Appln No. 09/900,224

Amdt date June 28, 2005

Reply to Office action of April 28, 2005

Amendments to the Drawings:

FIG. 1

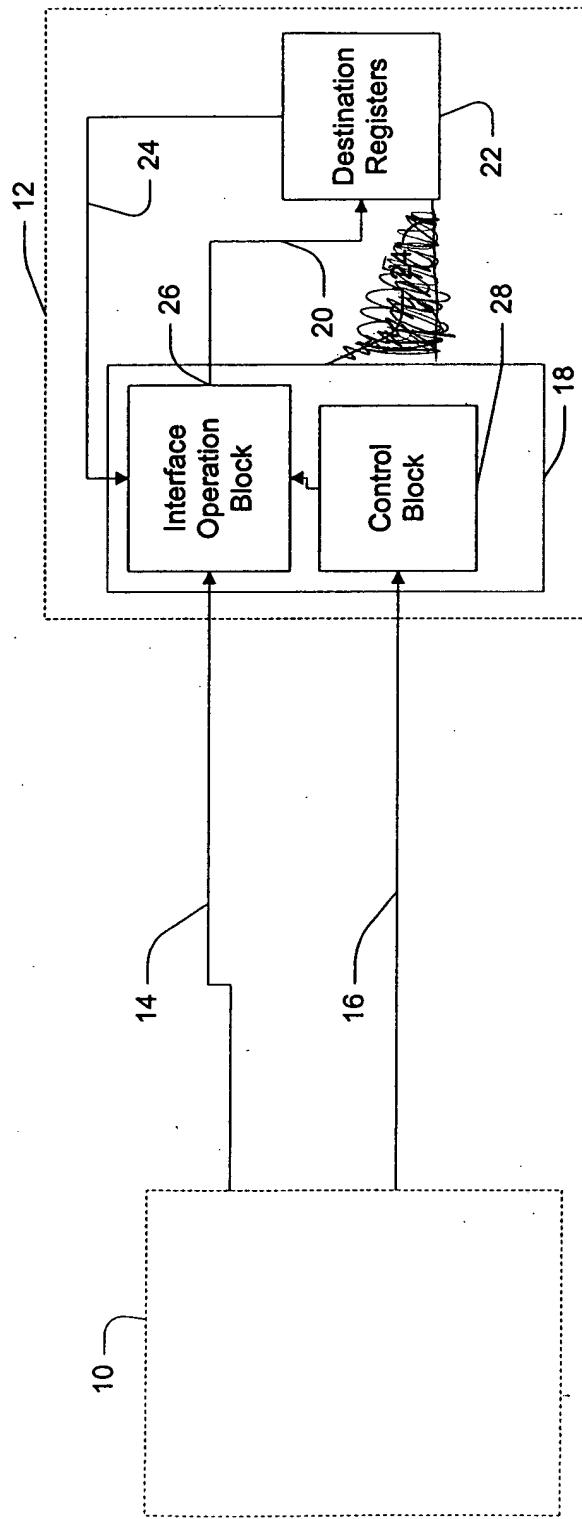
Applicant has amended Figure 1 to delete the second occurrence of reference numeral 24 as shown in annotated sheet 1 in the Appendix. Applicant also notes that the box associated with the second reference numeral 24 in Figure 1 is correctly identified with reference numeral 18. That this box is associated with reference number 18 is illustrated, for example, by the Specification at page 4, lines 21 - 28 and page 5, lines 2 - 6.
